Re: Gasco Production Company  
Gate Canyon State #34-21-11-15  
845' FSL and 1995' FEL  
SW SE Section 21, T11S - R15E  
Duchesne County, Utah

# APPLICATION FOR PERMIT TO DRILL

**DIVISION OF OIL, GAS AND MINING  
APPLICATION FOR PERMIT TO DRILL  
STATEMENT OF BASIS**

# 04-05 Gasco Gate Cyn 34-21-1-15

**Evaluation Ranking Criteria and Ranking Score  
For Reserve and Onsite Pit Liner Requirements**

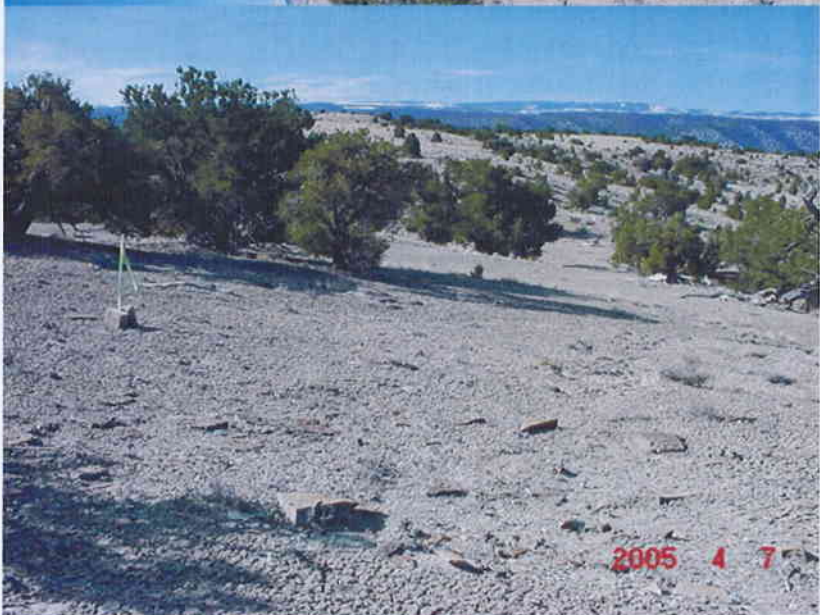
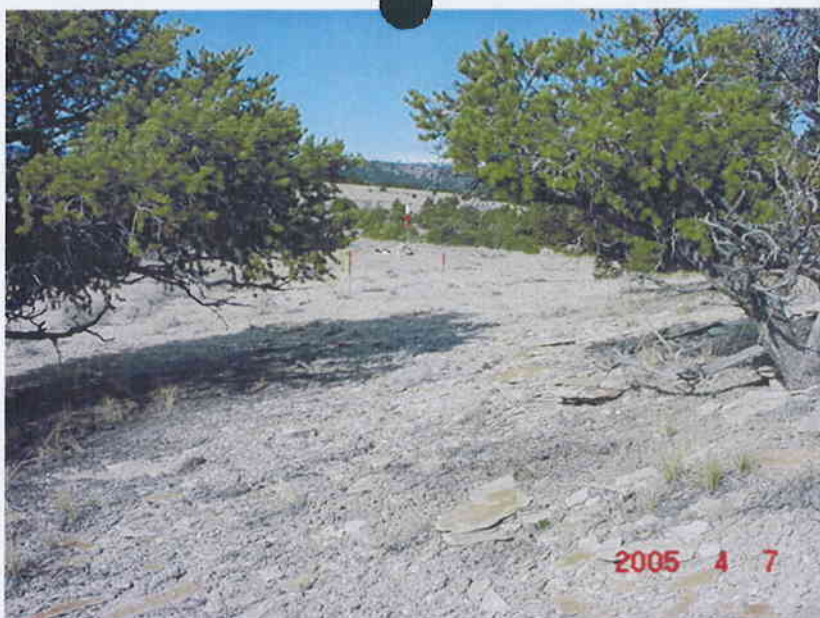
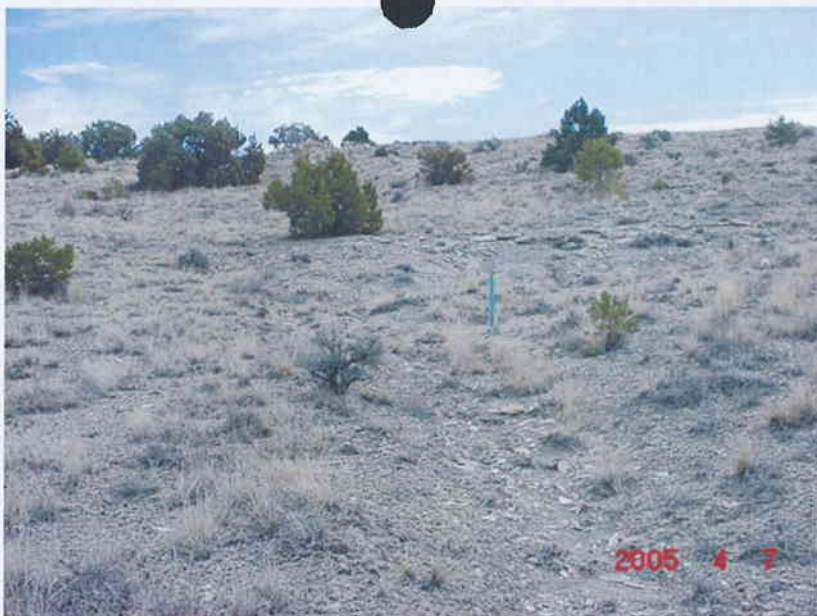
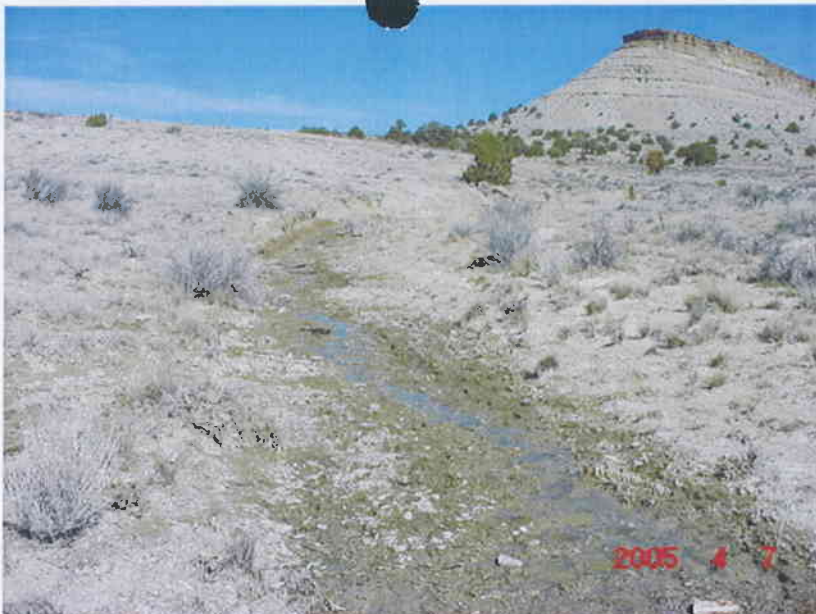
**Final Score**      20      (Level I Sensitivity)

Sensitivity Level I = 20 or more; total containment is required, consider criteria for excluding pit use.

1. A synthetic liner with a minimum thickness of 12 mils with a felt subliner shall be properly installed in the reserve pit.

## Casing Schematic

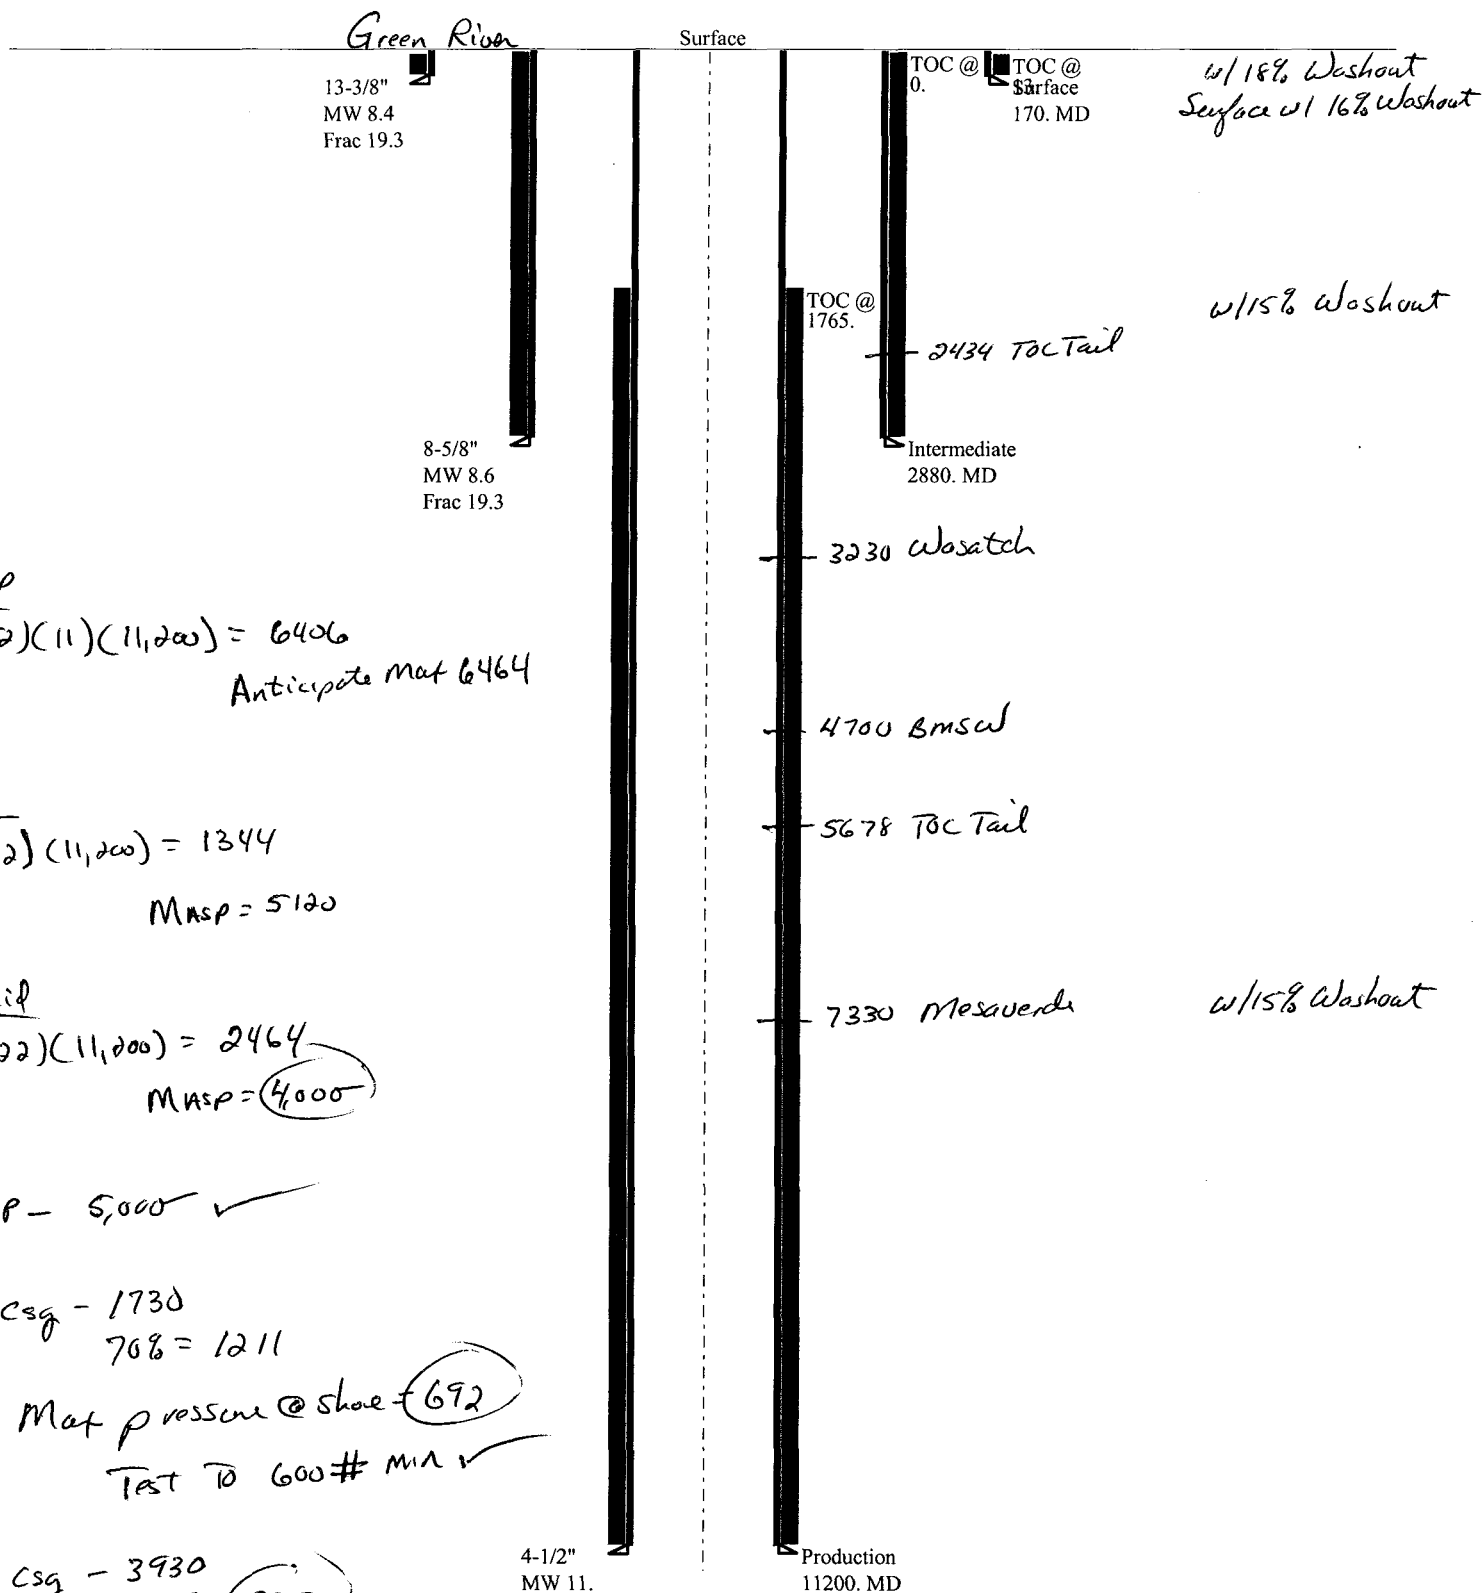
BHP

$$(1.052)(11)(11,200) = 6406$$

Anticipate mat 6464

Gao

$$(1.12)(11,200) = 1344$$

MASP = 5120

Fluid

$$(1.22)(11,200) = 2464$$

MASP = 4000

BOP - 5,000 ✓

Surf csg - 1730

70% = 1211

Mat pressure @ shoe = 692

Test to 600# min ✓

Int csg - 3930

70% = 2751

Mat pressure @ shoe = 4634

Test to 2700# min. ✓

✓ Adequate DWD 4/15/05
